PROPOSED DRAFT GLOBAL TECHNICAL REGULATION (GTR)
on
PEDESTRIAN PROTECTION.

This document is a working document circulated for discussion and comments. It is only submitted with the intention to facilitate discussion by the GRSP Informal Group.

GLOBAL TECHNICAL REGULATION NO. Y

Figure 6: Impact Point. (*insertion of impact angle example*)

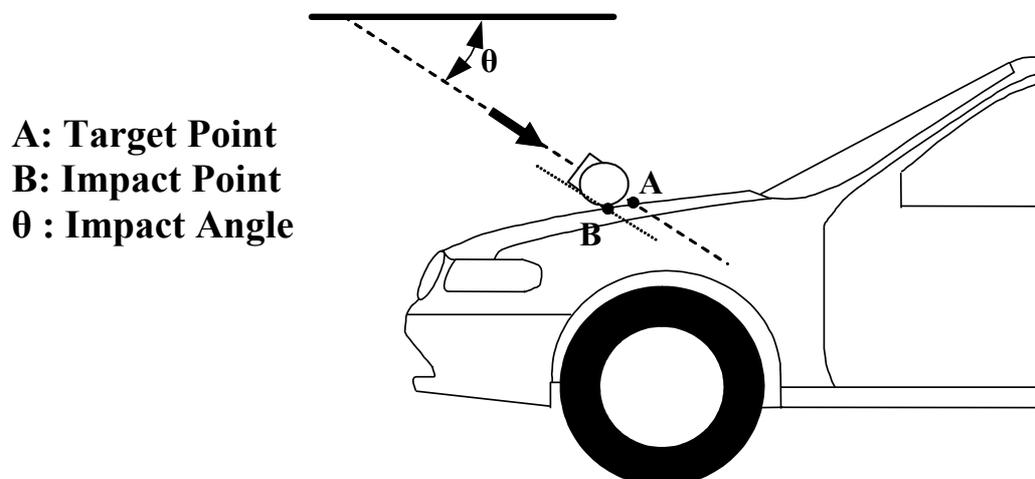
Figure 6 could be used to provide an example of the measured angle.

Figure 13c: Windscreen Lower Reference Line
This diagram requires more discussion and agreement.

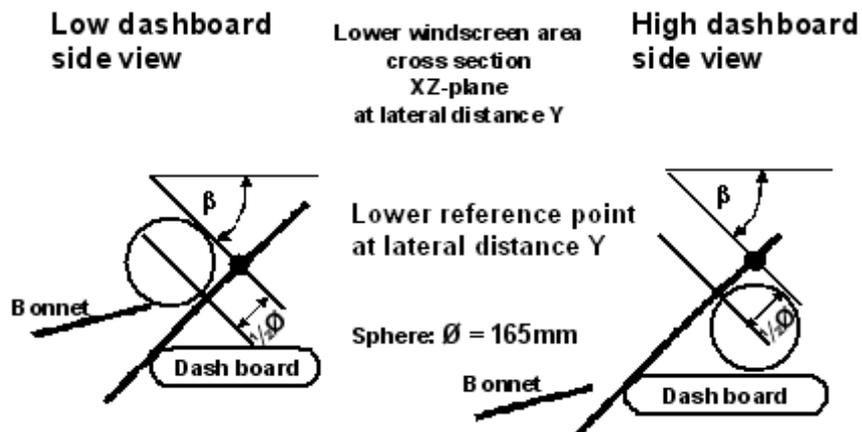
TO BE DEFINED, see Figure 13c.
